**PARTS & SERVICE
NEWS**

REF NO.	AT01157
DATE	Nov. 2, 2001

SUBJECT: OIL COOLER ELEMENT STUD BOLT BREAKAGE ON SA12V140 FOR HD785/985/D475A/WA800, 900

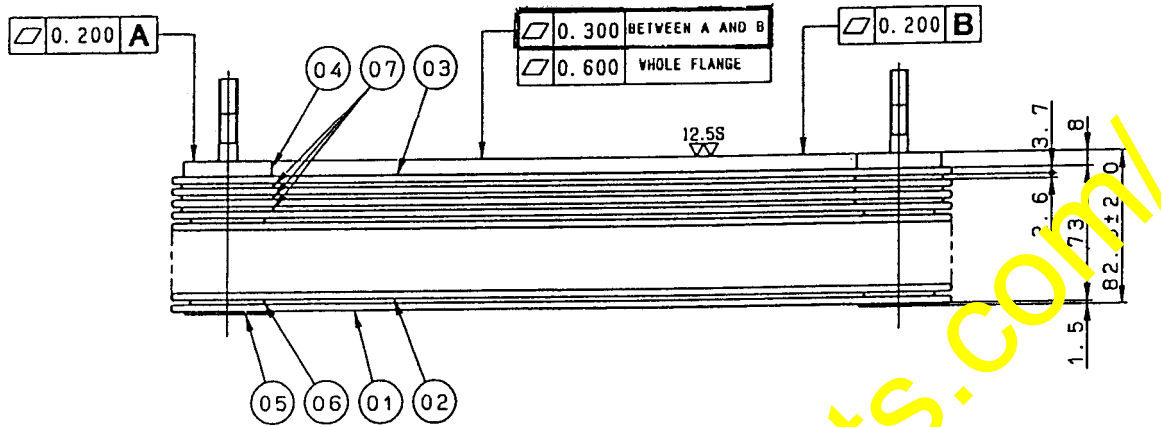
It has been found out that there may be a breakage failure with the stud bolt fastening the oil cooler element and the cover of the oil cooler ass'y being installed to the SA12V140 engines being used on the HD785, HD985, D475A, WA800 and WA900.

As the flatness of the mating flange surface to the cover of the oil cooler element has been improved, make the modification being introduced in this Service News when the above failure occurs.

Regarding the surface of the mating flange of the oil cooler element to the cover, the flange with insufficient co-relative flatness resulting from thermal influence occurring while in-furnace brazing process for the part was being made.

In the above case, fretting occurs on the flange surface to apply excessive stress to the stud bolt leading to possible breakage of the stud bolt.

4. The installation jig to use for the in-furnace brazing process has been improved to secure the necessary flatness of the flange surface.

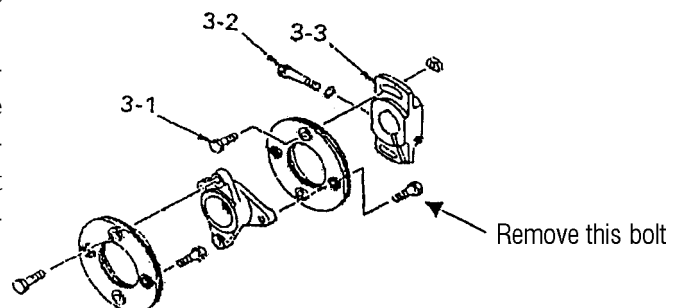
- ① Remove the fuel injection pipe, fuel hose, etc. referring to the Shop Manual.
- ② Engage the belts with the pump as shown in the schematic diagram shown below and engage the belts to the upper frame. Also, fasten these belts to the under frame using the lever block.

③ When separating the fuel injection pump from the drive shaft, remove the coupling bolt.

★ Meanwhile, before separating them, make appropriate marking to clarify the positioning. (In order not to let the fuel injection timing deviate.)

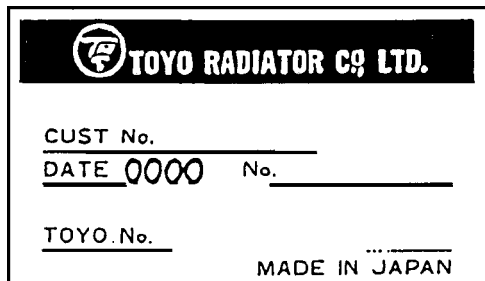
★ Tightening torque for the bolt:

M8 bolts: 27.5 – 34.3 Nm (2.8 – 3.5 kg-m)

M10 bolts: 58.8 – 73.5 Nm (6 – 7.5 kg-m)

Joint bolts (M14): 24.5 – 34.3 Nm (2.5 – 3.5 kg-m)

Air compressor intake port: 68.6 - 93.1 Nm (7 – 9.5 kg-m)

Unloader takeout port: 22.6 – 29.4 Nm (2.3 – 3 kg-m)

When installation work is finished, re-check the fuel injection timing.
